ADDENDUM #2

Date: May 15, 2017

**A NEW BRANCH BANK BUILDING
THE BANK OF COMMERCE
SHELLEY, IDAHO**

E2.0

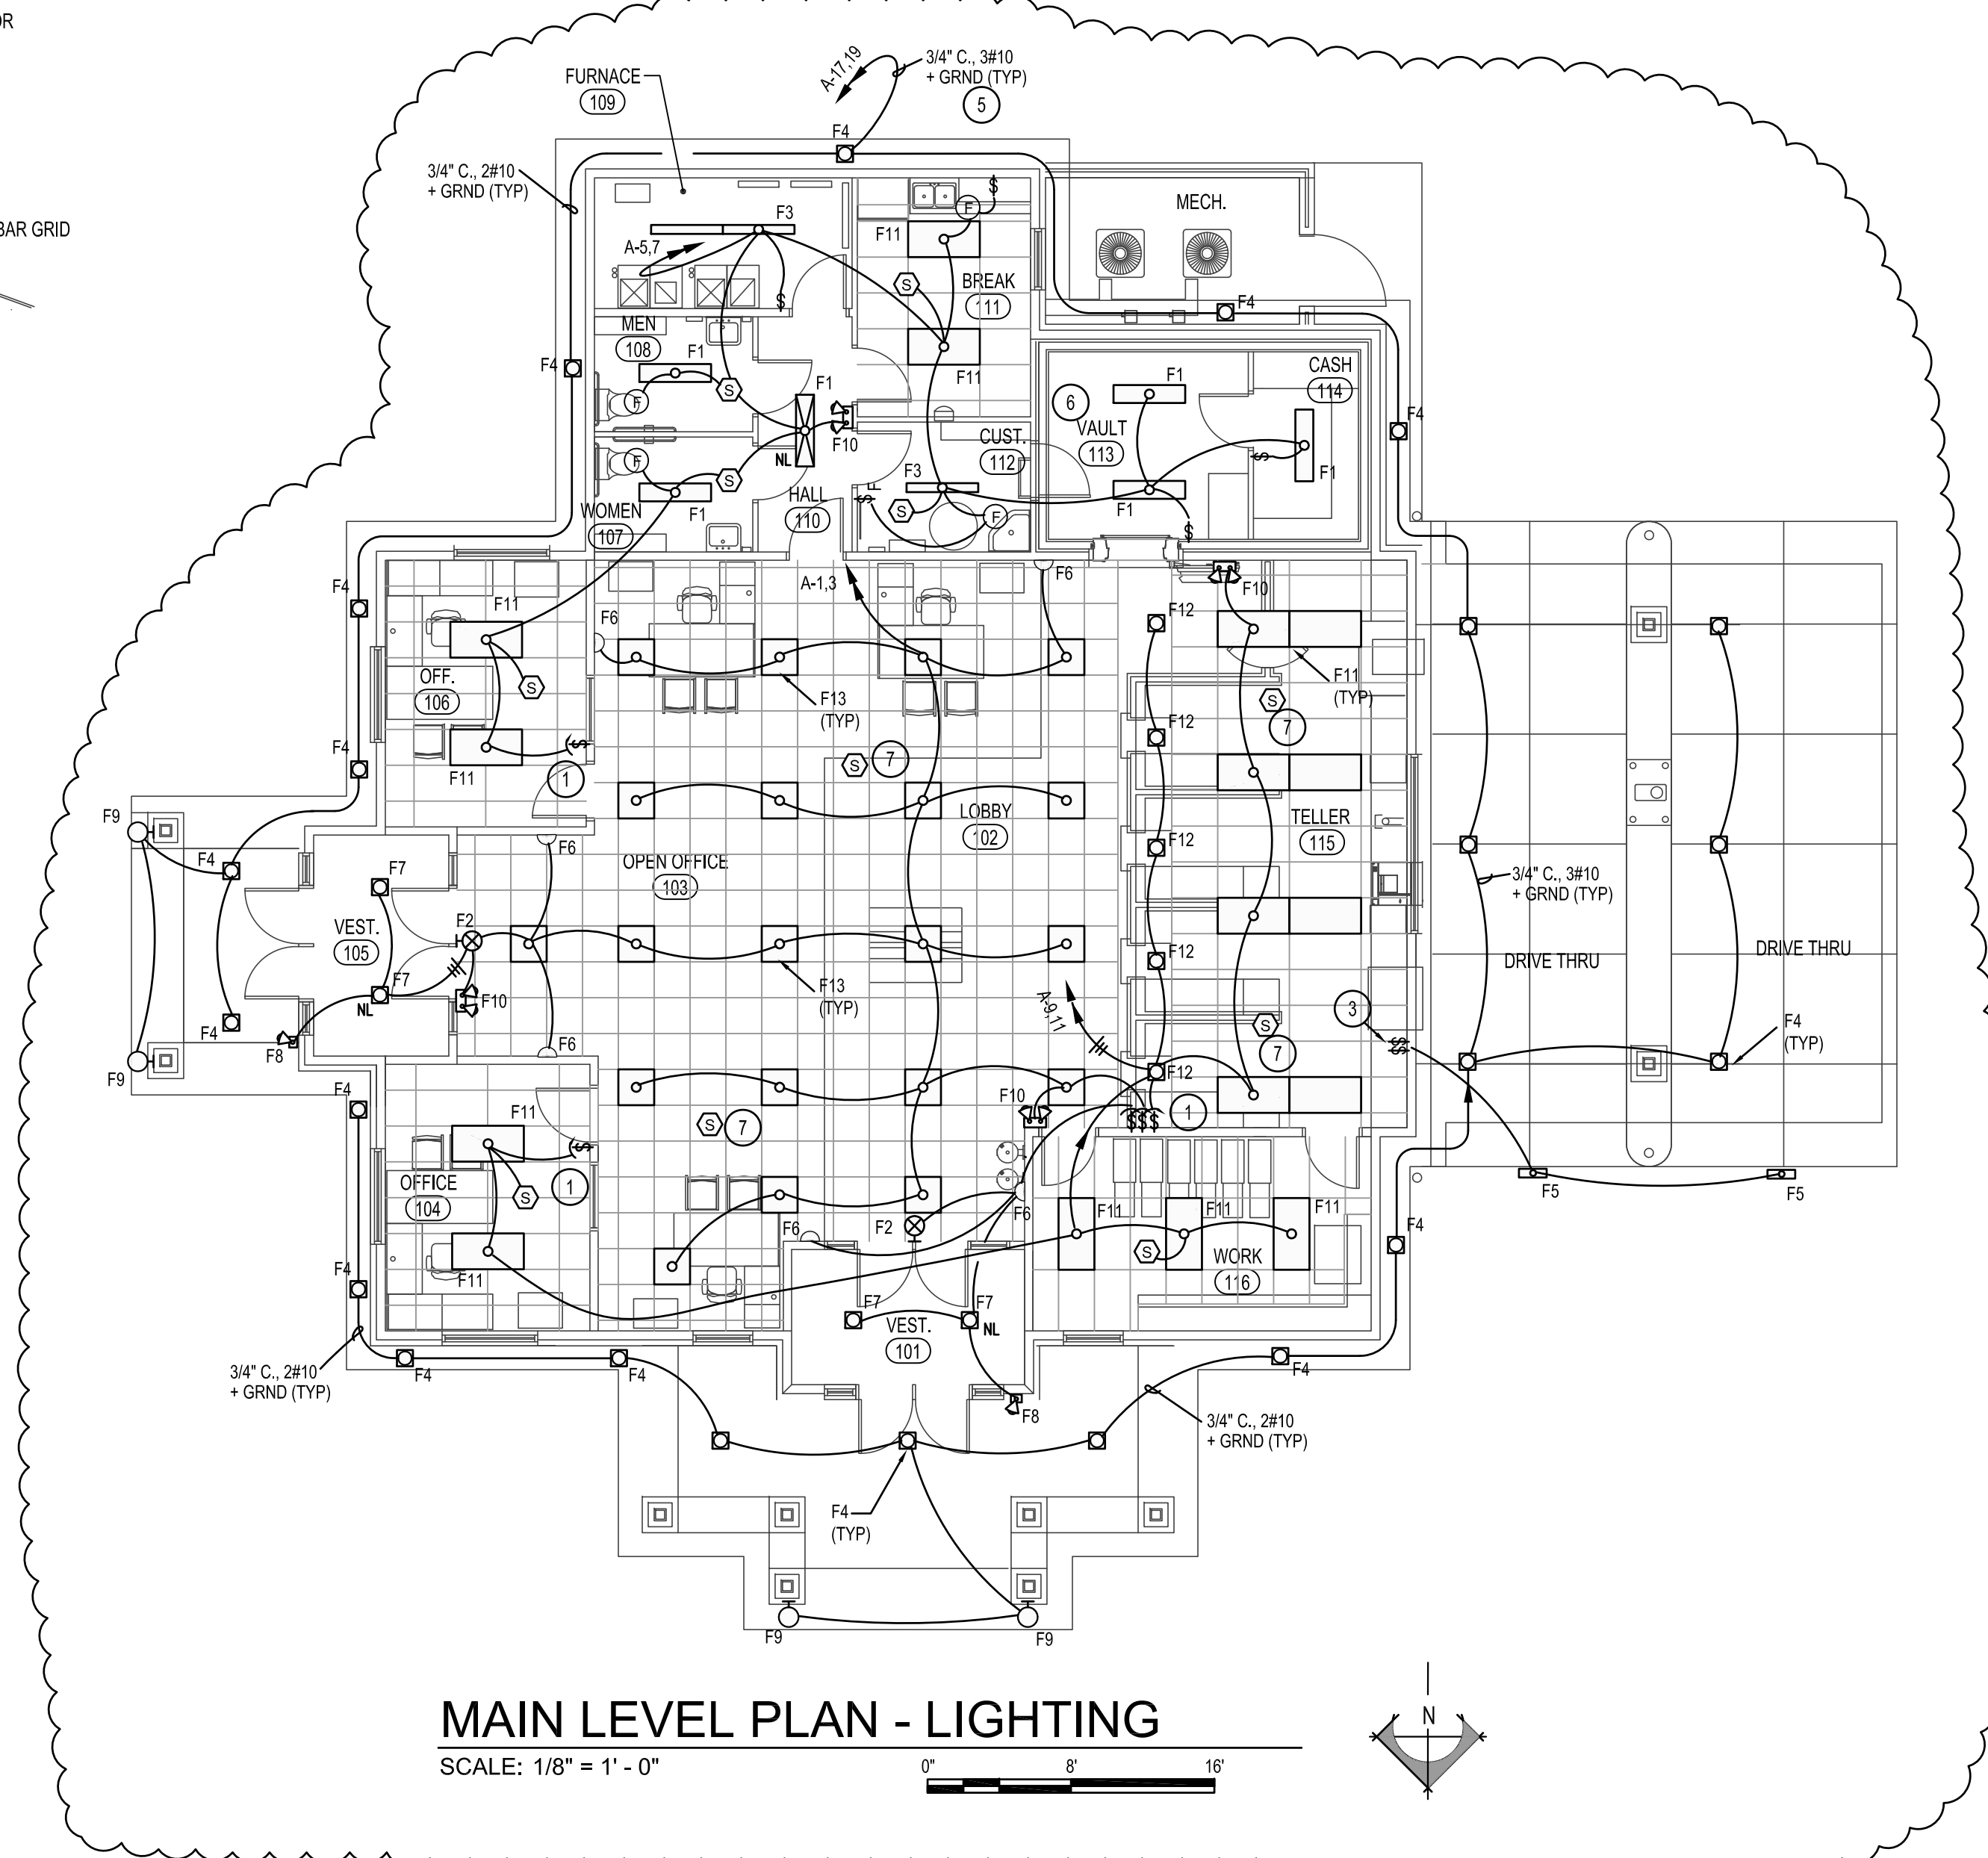
1. Drawing Sheet E2.0 attached. Revised lighting control in Lobby and Teller area, See attached.
2. Drawing Sheet E2.0 attached. Modified keynotes 1 and 7, See Attached.
3. Drawing Sheet E2.0 attached. Added prior approvals, See Attached.

- KEY NOTES**
- 1 PROVIDE ON/OFF/10-10V DIMMING AS SHOWN. PROVIDE AND INSTALL CONDUCTORS AND CONNECTIONS.
 - 2 LOCATE LIGHT FIXTURES IN MECHANICAL ROOMS AFTER ALL MECH. EQUIP. IS IN PLACE. ADJUST FIXTURE LOCATIONS TO BEST SUITE THE MECH. PIPING, DUCTWORK, ETC. PROVIDE CHAIN SUSPENSION KITS AS NECESSARY TO SUSPEND BELOW DUCTS, IF NECESSARY.

- 3 THREE POSITION TOGGLE SWITCH (TYPICAL OF 3) LABEL EACH SWITCH WITH A PERMANENT MICARTA LABEL THAT INDICATES WHICH LANE FIXTURE IT CONTROLS.
 - 4 CONNECT LIGHTING CIRCUITS IN THIS AREA SUCH THAT ONE CIRCUIT CONTROLS THE CENTER LAMP IN EACH FIXTURE AND THE OTHER CIRCUIT CONTROLS TO TWO OUTBOARD LAMPS IN EACH FIXTURE. THESE FIXTURES ARE ALSO SWITCHED IN SAME FASHION, AS CALLED OUT IN NOTE 1 ABOVE.

- 6 PROVIDE AND INSTALL AN F1 FIXTURE, SWITCH AND RECEPTACLE IN STORAGE ROOM ABOVE VAULT. CONNECT TO VAULT LIGHTING CIRCUIT.
 - 7 CONNECT OCC SENSORS IN THIS ROOM SUCH THAT ANY SENSOR WILL ACTIVATE ALL OF THE LIGHTING.
